**ADDENDUM NO. 1**

For Project: **THE EASTERN IOWA AIRPORT  
2011 PAGING SYSTEM REPLACEMENT  
CEDAR RAPIDS IOWA**

Architect's Commission No.: FIE1102

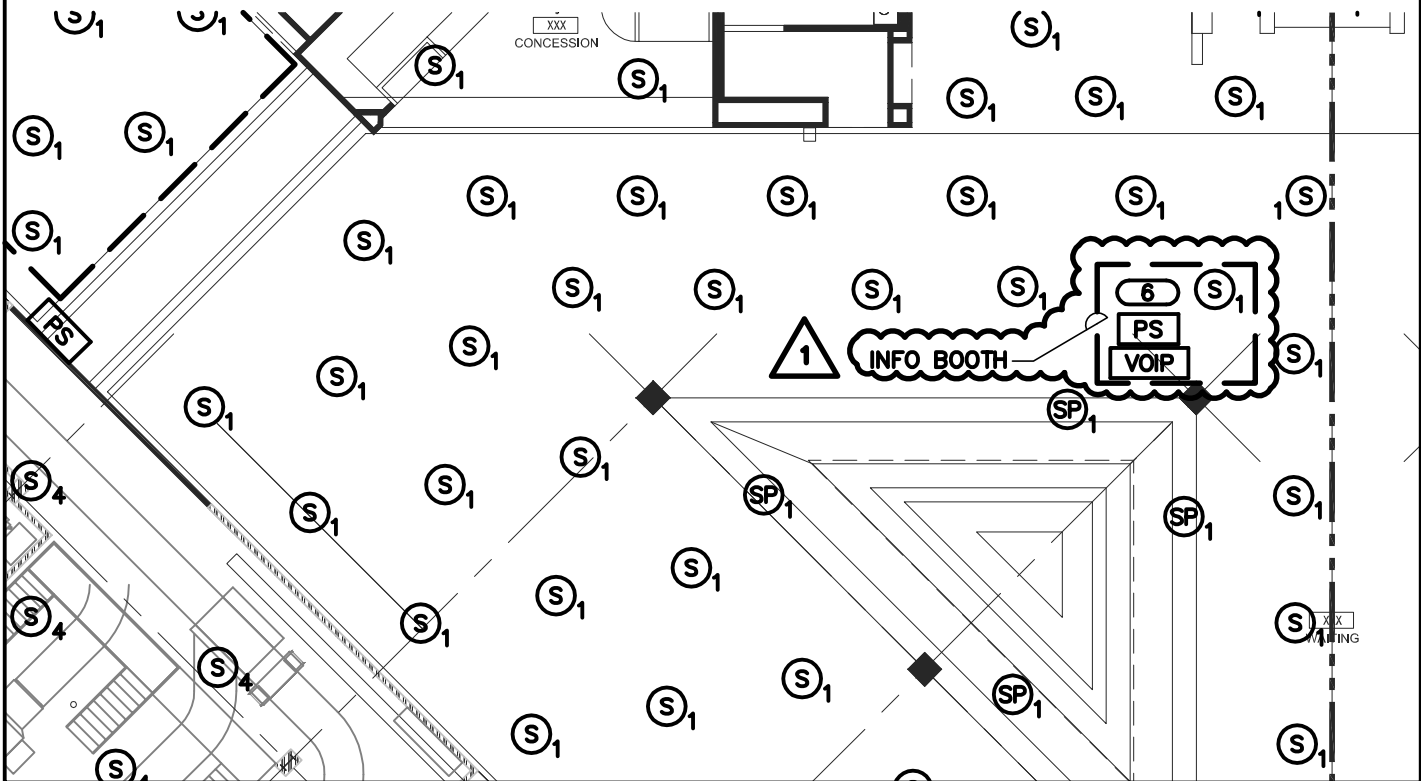
3. **ADD** five (5) mic demo symbols [mic] to rental car counters as shown on supplemental sketch ADD1.T3

ADD1.T1

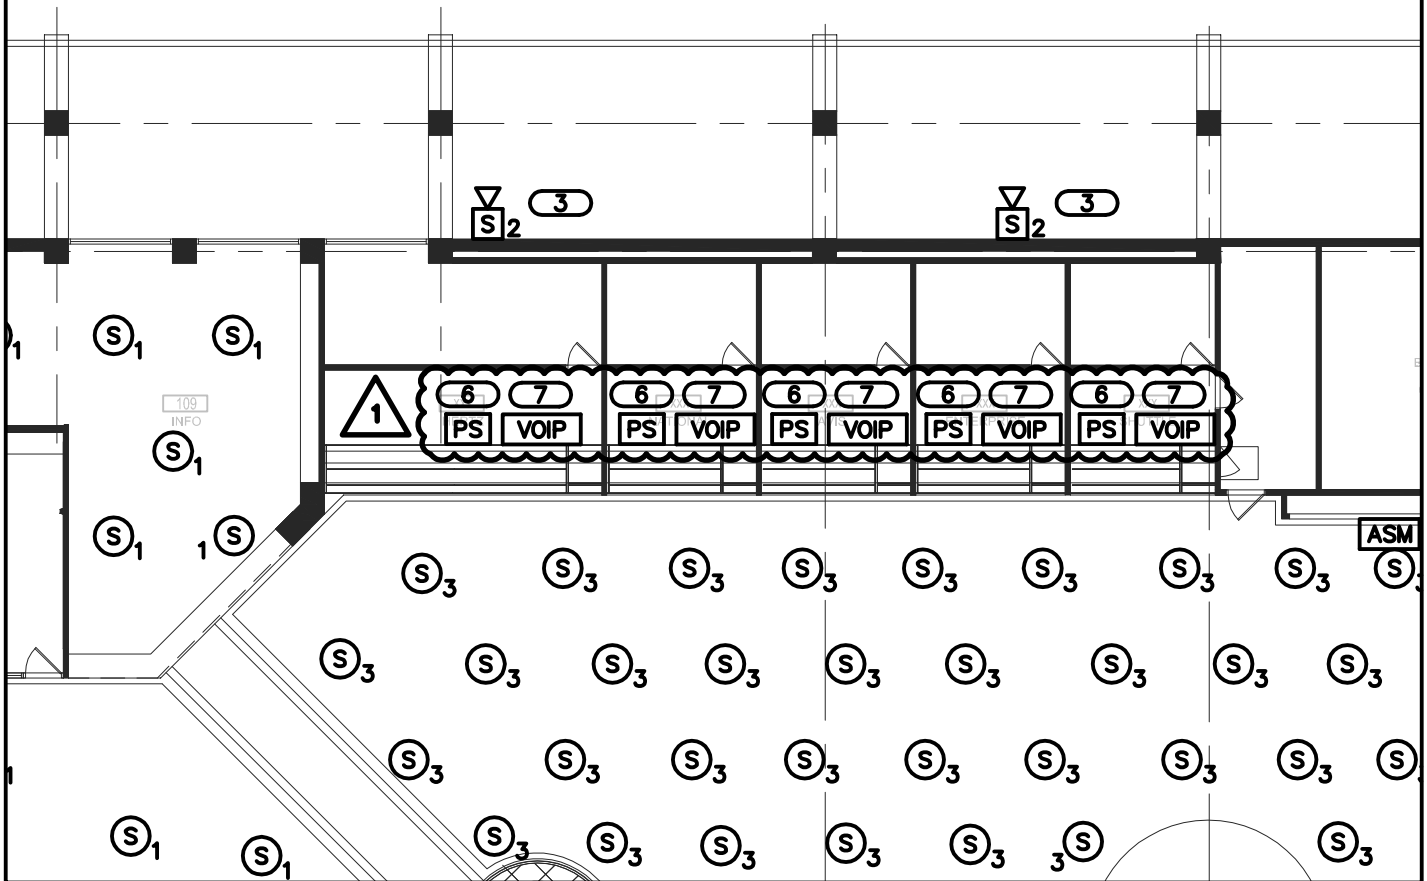
1. **REVISE** Keynote #5 to read as follows: "Contractor provided and owner installed (1) one VoIP Telephone at each ticket counter. Contractor shall verify quantities." as shown on supplemental drawing ADD1.T1.
2. **ADD** Keynote #6 to read as follows: "Install paging microphone in existing casework. Route cabling through existing power pole, up to above accessible ceiling." as shown on supplemental drawing ADD1.T1.
3. **REVISE** keynote symbol from #1 to #6 at information booth as shown on supplemental drawing ADD1.T1

1. INSTALL MICROPHONE IN EXISTING CASEWORK. ROUTE MIC CABLE THROUGH CASE WORK TO NEAREST WALL AND UP TO ABOVE ACCESSIBLE CEILING. PROVIDE AND INSTALL (1) PAGING STATION PER AIRLINE. CONTRACTOR SHALL VERIFY QUANTITIES.
  2. SPEAKER LOCATED IN CEILING BASEMENT LEVEL.
  3. MATCH MOUNTING HEIGHT AND ANGLE OF EXISTING SPEAKERS.
  4. COIL 10' OF SPARE SPEAKER CABLE ON FIRST AND LAST SPEAKER IN THIS AREA TO ACCOMMODATE FUTURE CEILING HEIGHT.
5. CONTRACTOR PROVIDED OWNER INSTALLED (1) ONE VoIP TELEPHONE AT EACH TICKET COUNTER. CONTRACTOR SHALL VERIFY QUANTITIES.
6. INSTALL MICROPHONE IN EXISTING CASEWORK. ROUTE CABLING THROUGH EXISTING POWER POLE UP TO ABOVE ACCESSIBLE CEILING.

ADD1.T2

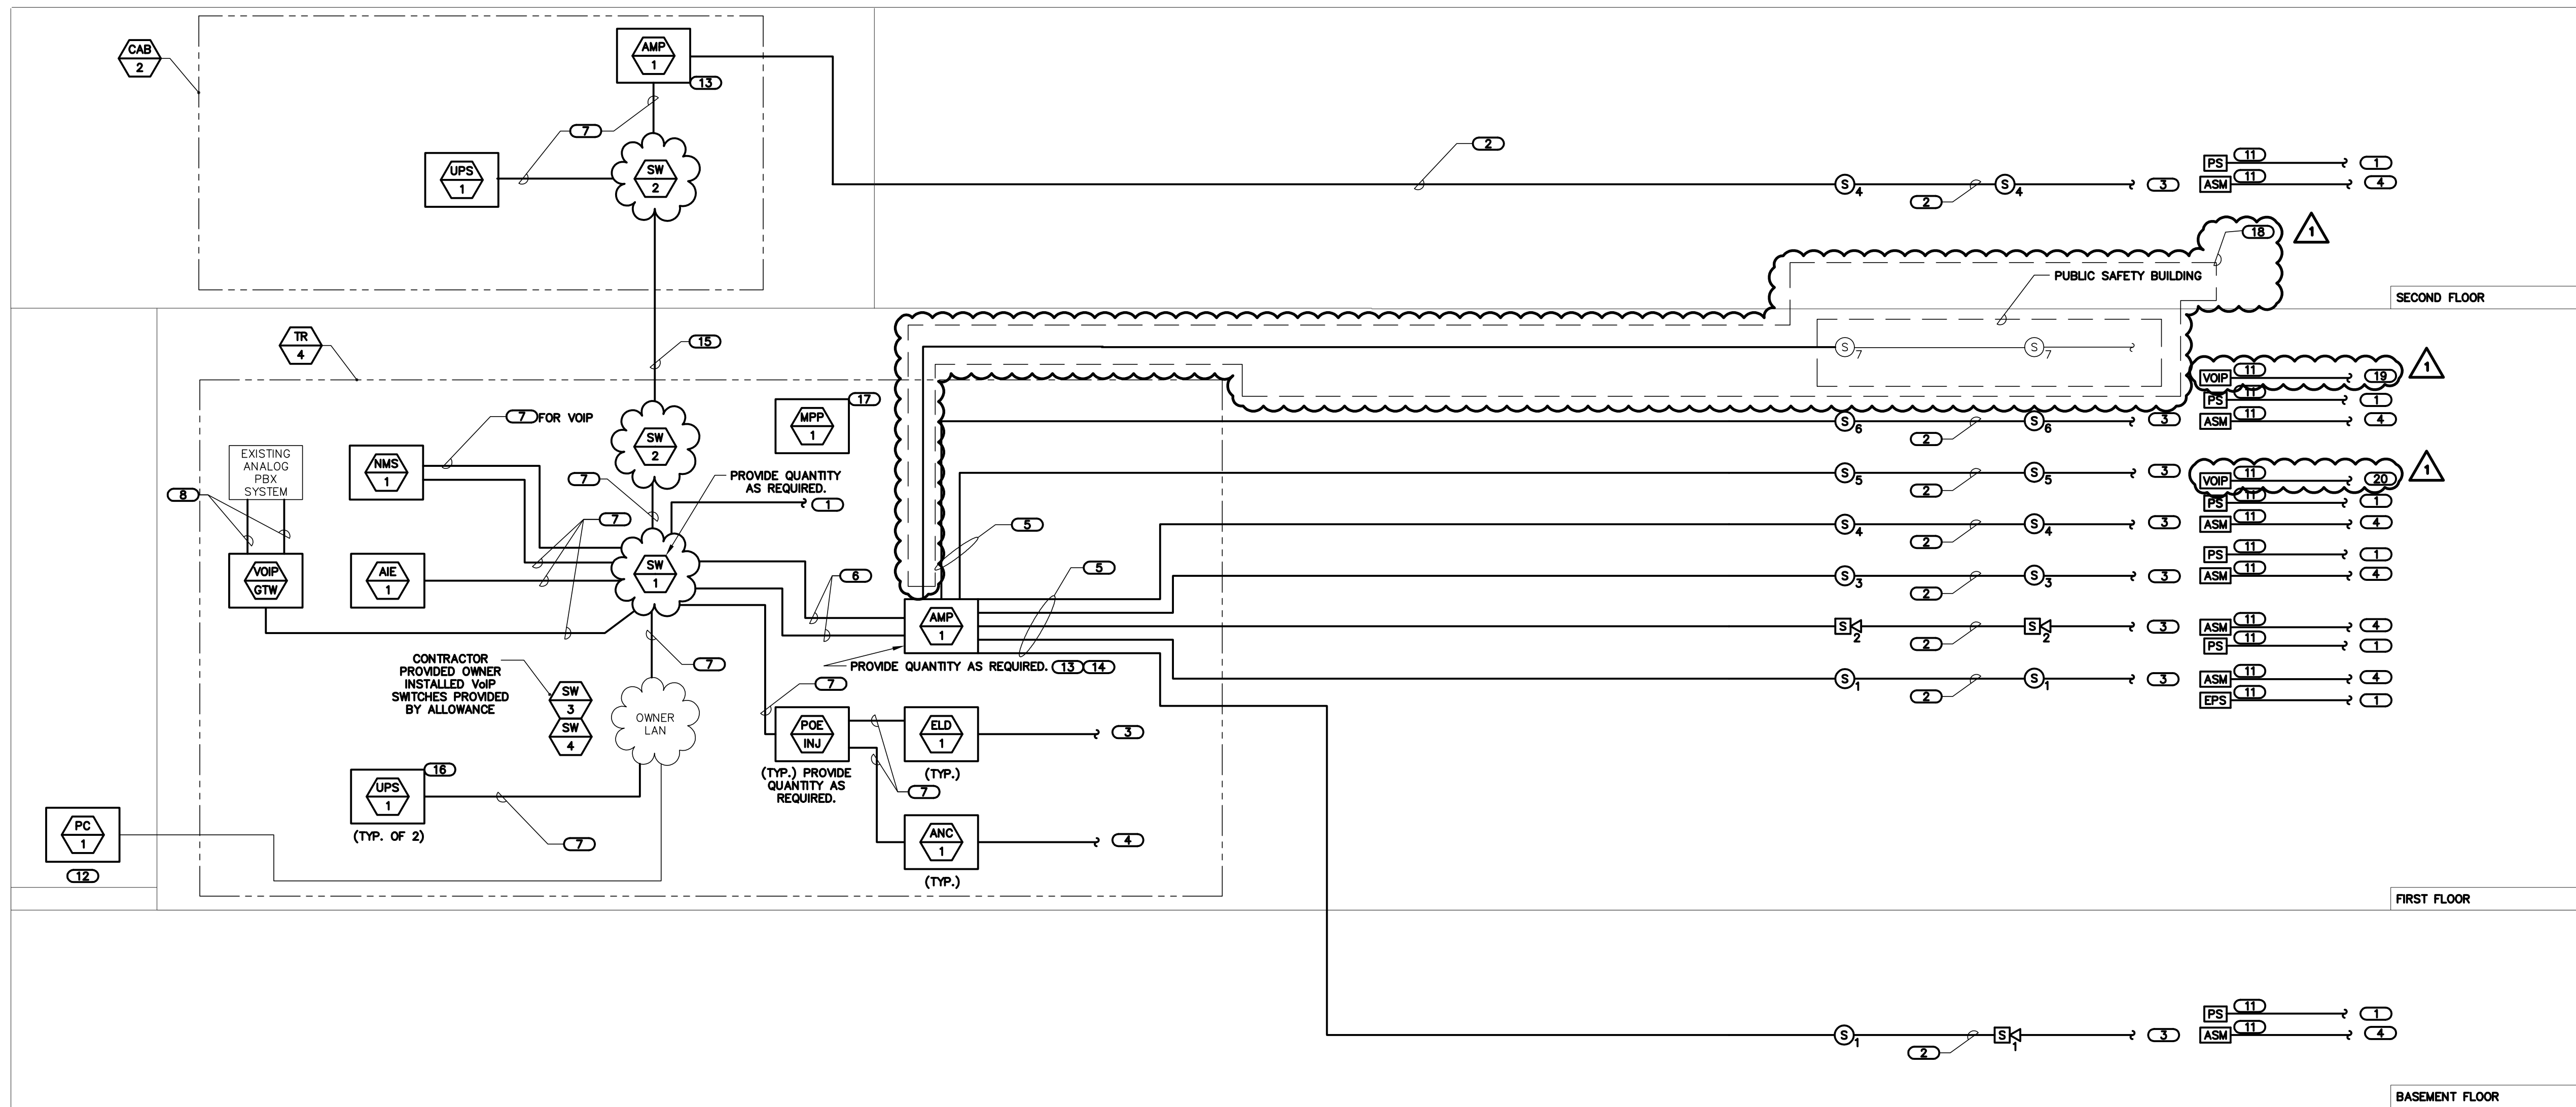
1. **ADD** Keynote #6 to read as follows: "Install microphone in existing casework. Route mic cable through casework to nearest wall and up to above accessible ceiling." as shown on supplemental drawing ADD1.T2
2. **ADD** Keynote #7 to read as follows: "Contractor provided and Owner installed VoIP telephone." as shown on supplemental drawing ADD1.T2
3. **ADD** five (5) paging stations [PS] and five (5) VoIP telephones [VOIP] and keynote symbols #6 and #7 to rental car counters as shown on supplemental sketch ADD1.T2.

6. INSTALL MICROPHONE IN EXISTING CASEWORK. ROUTE MIC CABLE THROUGH CASEWORK TO NEAREST WALL AND UP TO ABOVE ACCESSIBLE CEILING.

7. CONTRACTOR PROVIDED AND OWNER INSTALLED VOIP TELEPHONE.

ADD1.T4

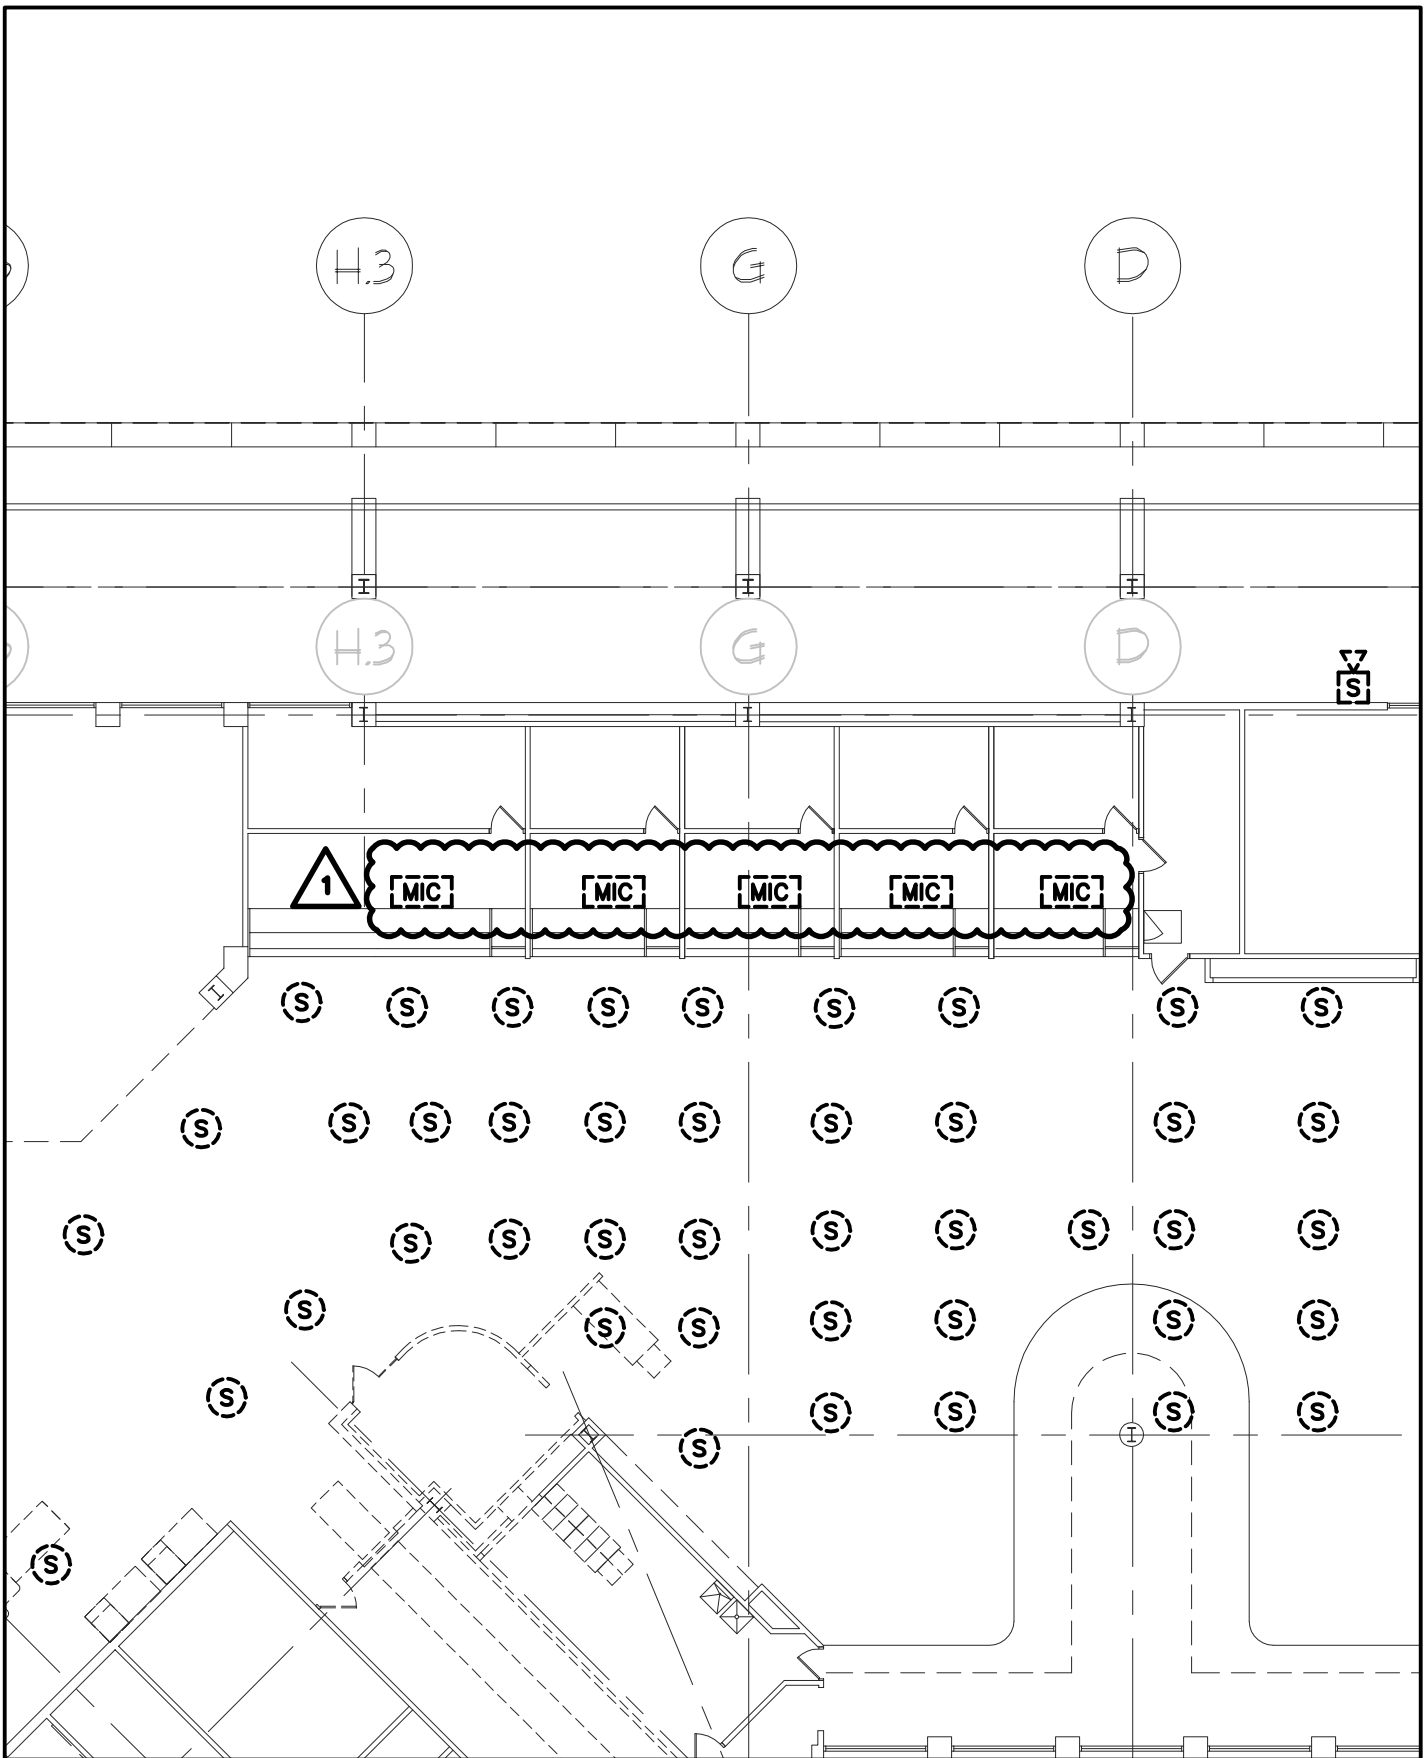
2. **REVISE** Materials List Item # 2 as shown on supplemental Sketch ADD1.T4

ITEM NO.	SYMBOL	DESCRIPTION	APPROVED MANUFACTURERS
1		MODULAR PATCH PANEL, 48 MODULAR RJ-45 TERMINATIONS, MOUNTS DIRECTLY TO EIA/TIA STANDARD 19" RELAY RACK, PORT IDENTIFICATION NUMBERS, PROVIDED WITH COLOR CODING AND LABEL HOLDER KITS, U.L. LISTED. REQUIRES (2) 1.75" MOUNTING SPACES.	PANDUIT PATCH PANEL CPPL48WBL
2		DESKTOP OR WALL MOUNTED NETWORKED PAGING STATION. PUSH TO TALK BUTTON WITH STATUS INDICATION, 999 USER-CONFIGURABLE PAGE CODES, 4 PRIORITY LEVELS AND 4 EMERGENCY PRIORITY LEVELS, LOCAL DIGITAL SIGNAL PROCESSING, EMBEDDED DSB AND ON BOARD MEMORY, LOCAL STORAGE, BUILT IN STORE AND FORWARD FUNCTIONALITY, COBRANET AUDIO/CONTROL, BACKLIT LCD DISPLAY, NOISE CANCELING HANDHELD MICROPHONE.	BIAMP WALL MOUNT WS-10 DESKTOP DS-10
3		WALL MOUNTED NETWORKED EMERGENCY PAGING STATION. CERTIFIED FOR USE IN AN EN 54-16 COMPLIANT LIFE SAFETY SYSTEM. PUSH TO TALK BUTTON WITH STATUS INDICATION, 999 USER-CONFIGURABLE PAGE CODES, 4 PRIORITY LEVELS AND 4 EMERGENCY PRIORITY LEVELS, LOCAL DIGITAL SIGNAL PROCESSING, EMBEDDED DSP AND ON BOARD MEMORY, LOCAL STORAGE, BUILT IN STORE AND FORWARD FUNCTIONALITY, COBRANET AUDIO/CONTROL, BACKLIT LCD DISPLAY, NOISE CANCELING HANDHELD MICROPHONE.	IED PEAVEY
